# **Town Creek Restoration Project – Option B Year 3 Monitoring Report**

**DMS Project ID Number – 95026; NC DEQ Contract No. 003990**

**Subject:** Task 9: Annual Final Monitoring Report – Monitoring Year 3 & Response to Comments  
Town Creek Restoration Project – Option B  
Yadkin River Basin – CU# 03040105 – Stanly County, NC  
NCDMS Project ID No. 95026; NCDEQ Contract No. 003990

**Figure 3. Cross-sections with Annual Overlays**  
**Town Creek Restoration Project: Project No. 95026**

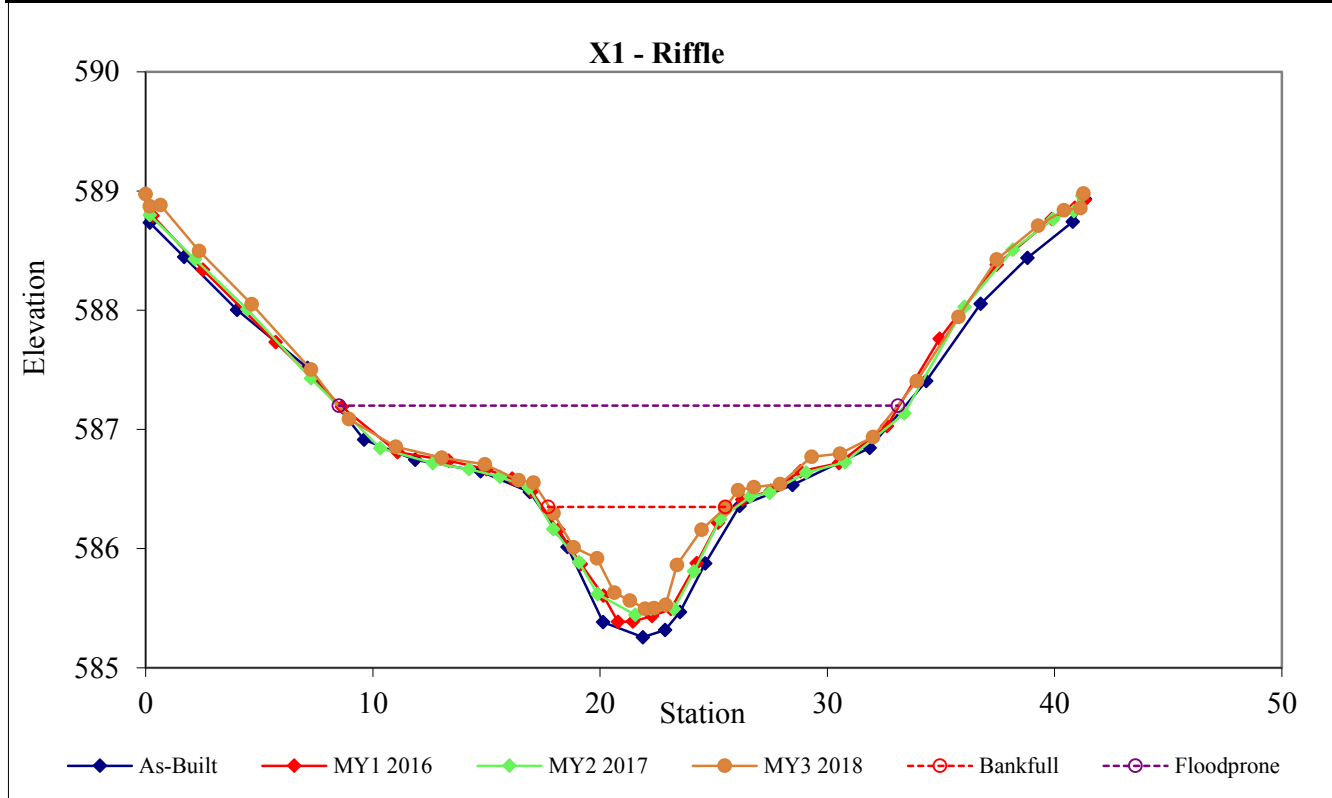
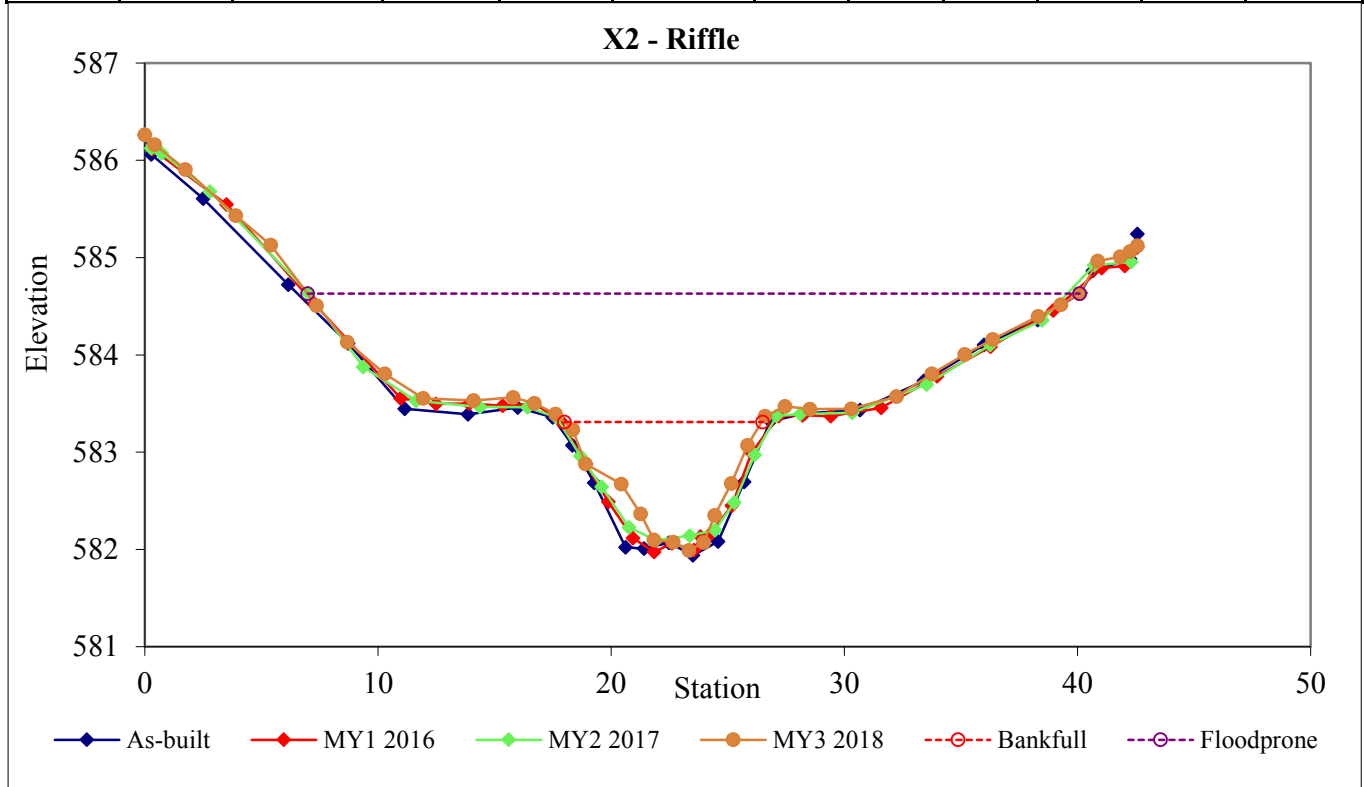
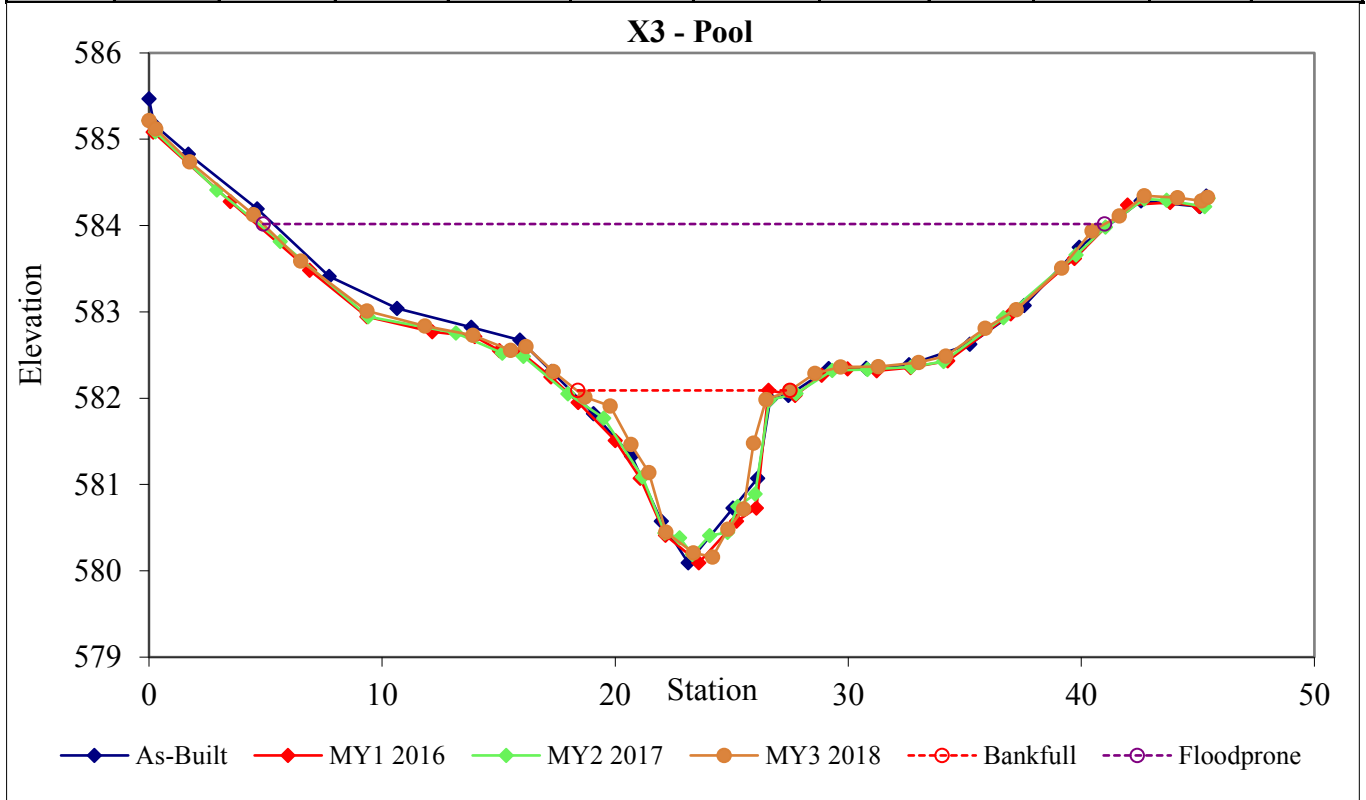
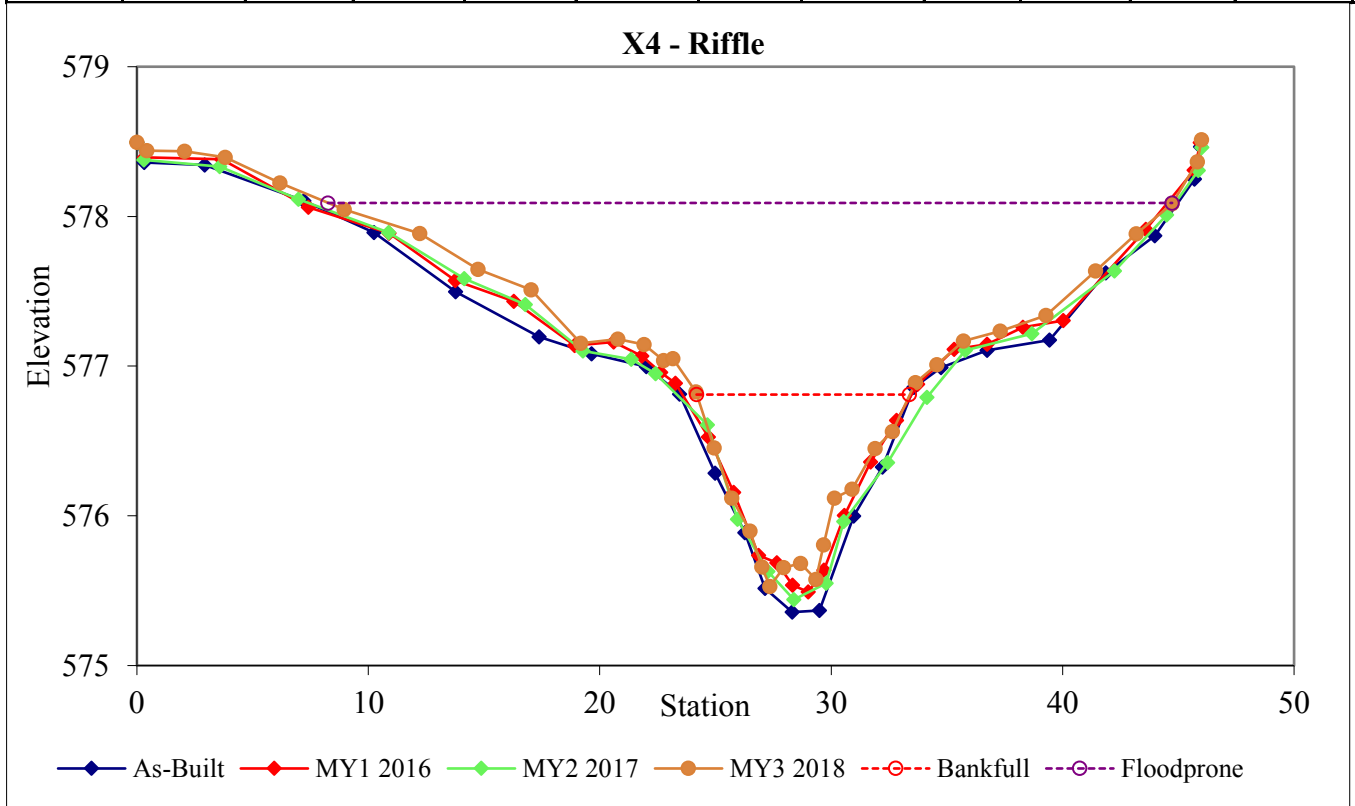
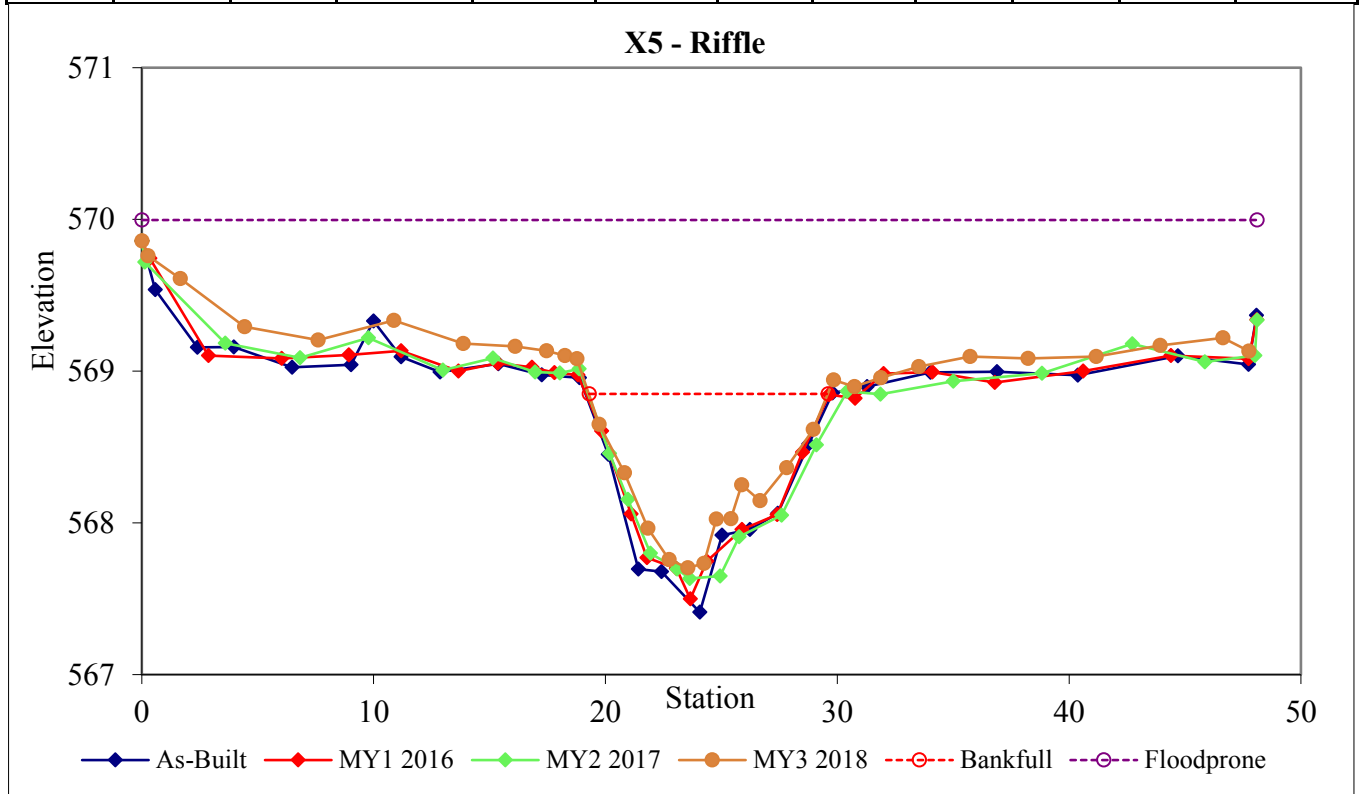
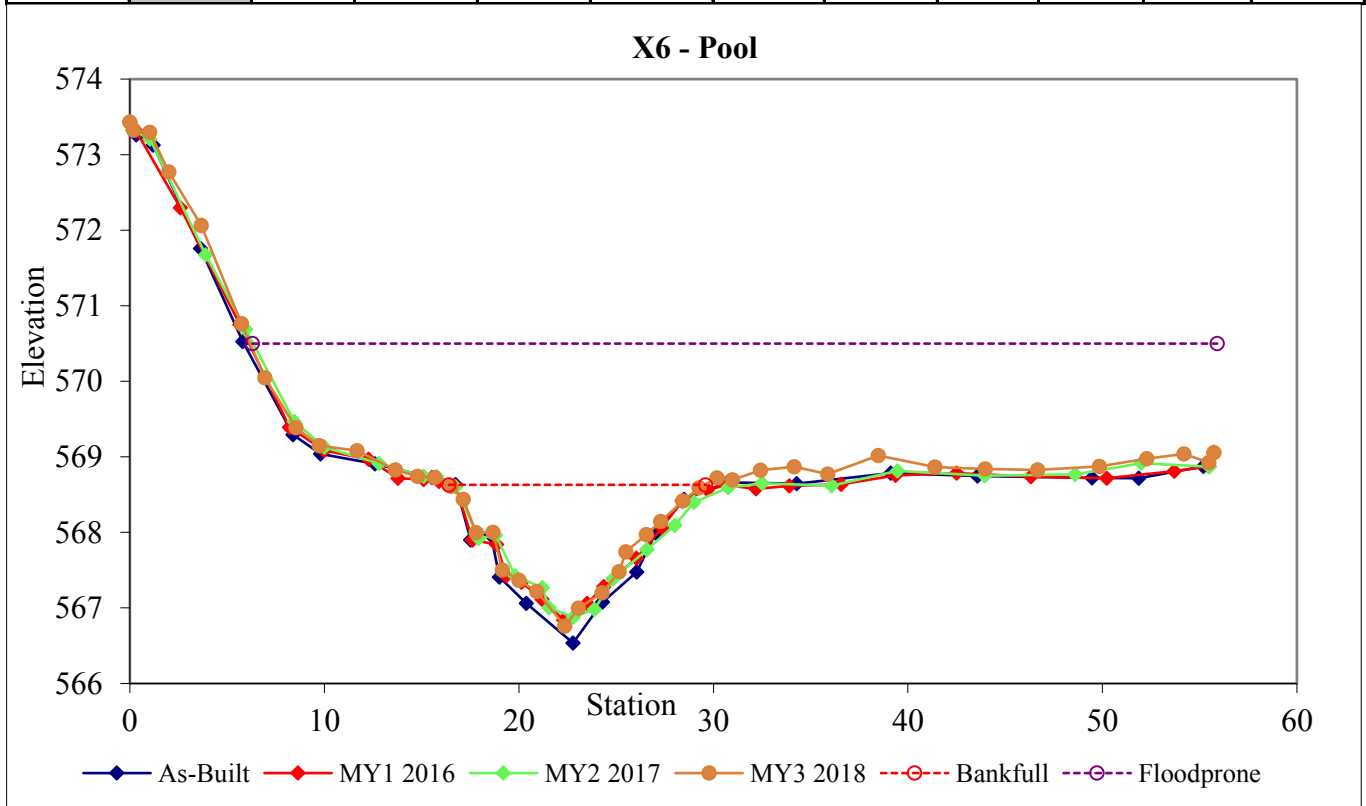
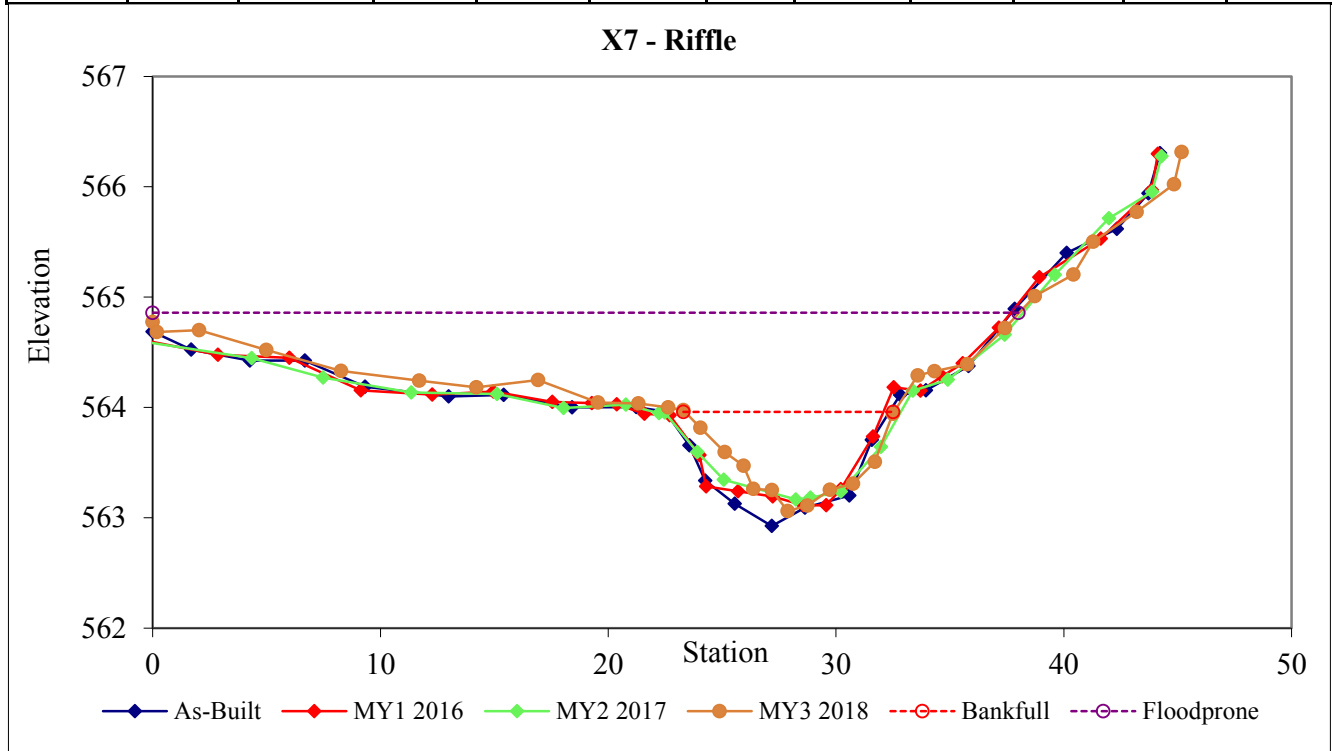
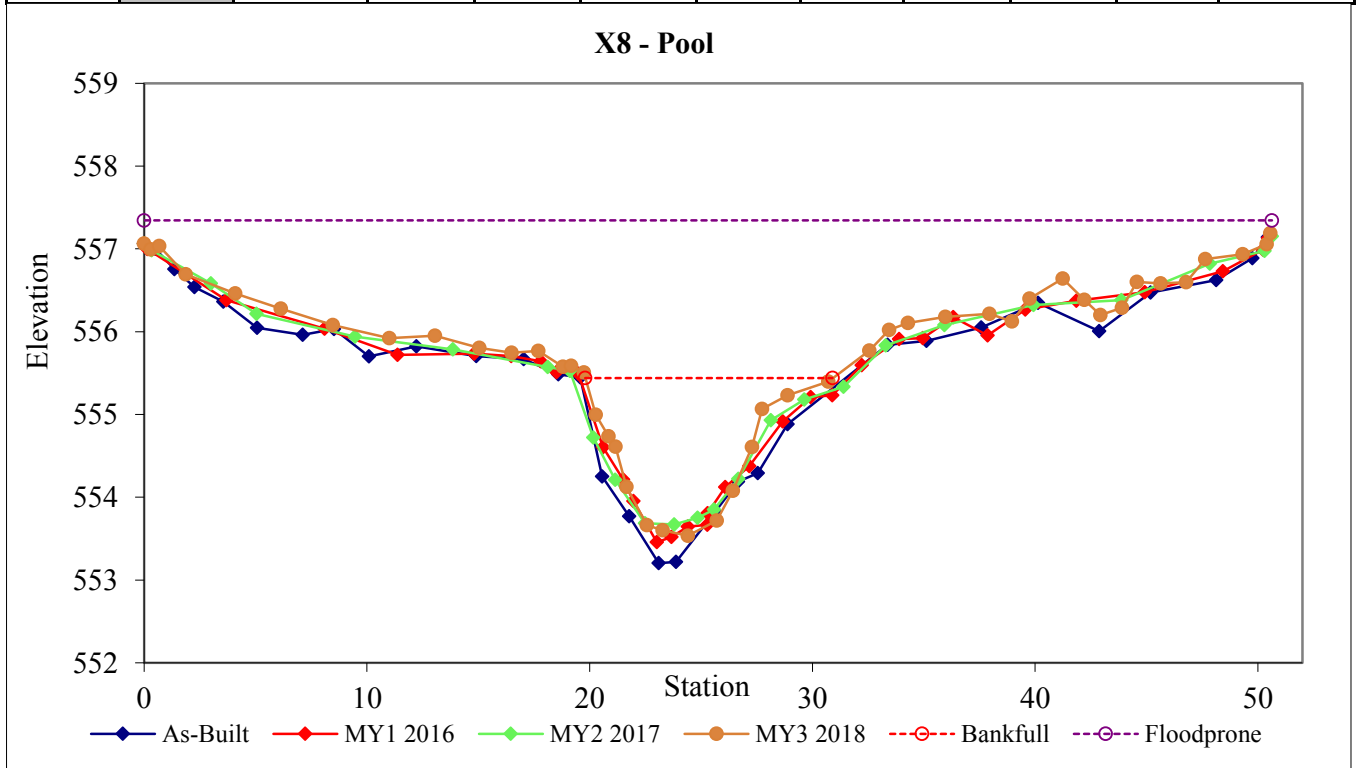
**Cross Section Graphs** – should indicate whether it is a pool or a riffle. Understood that the x-section table has this information, but it also needs to be on the graphs so the reader can have some context without having to flip back and forth.

**Response** – *The indication of whether the cross-section is a riffle or pool has been added to both the cross-section heading and the graph for each cross-section.*
